COMPLAINT INVESTIGATION REPORT

Project Name:	Mountain Valley Pipeline	Inspector:	Marshall Willis, Matthew Grant
Inspection Date:	Wednesday, August 10, 2022	Project Contact:	Brian Clauto, Cory Chalmers
Spread H: Montgomery County	STA 12532+00 - 12544+27 MVP-MN-278.01	Weather:	Dry

3. Are	eas of of	ffsite :	sediment deposition ob	oserve	d?				\boxtimes			
Background: This investigation was conducted in response to a complaint (IR#: 306014) received on August 09, 2022 for the MVP ROW at Yellow Finch Lane (MVP-MN-278.01). 1. The complaint states "failure of erosion and sediment control supersilt fence. Sediment filled water went under ESCs on the corridor and along the access road", and describes ESC devices diverting "polluted water directly into the stream." Observations: 1. Controls were in place and functioning properly along MVP-MN-278.01 and within the ROW from STA 12532+00 to 12544+27. 2. ROW was adequately stabilized and no sediment deposition off ROW was observed. 3. One maintenance item was noted during the inspection. See below. 4. No evidence of undermined controls was found. 5. Significant erosion occurring adjacent to the MVP ROW on denuded landowner driveway is causing

Figure 7: MVP-MN-278.01 – Landowner driveway adjacent to MN-278.01.

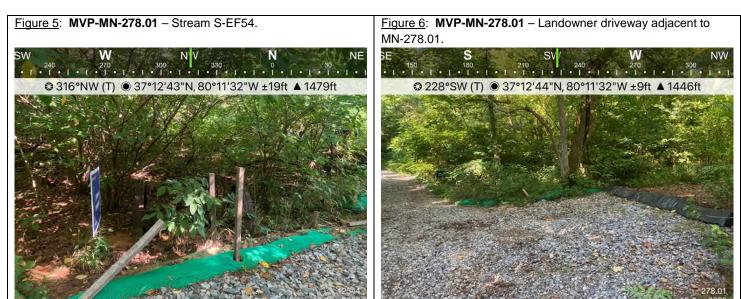
- MVP-MN-278.01: Maintain triangular silt dike by removing sediment build up from erosion on landowner access road.

Recommended Corrective Action: Maintain and install all controls per the approved PSS&S.
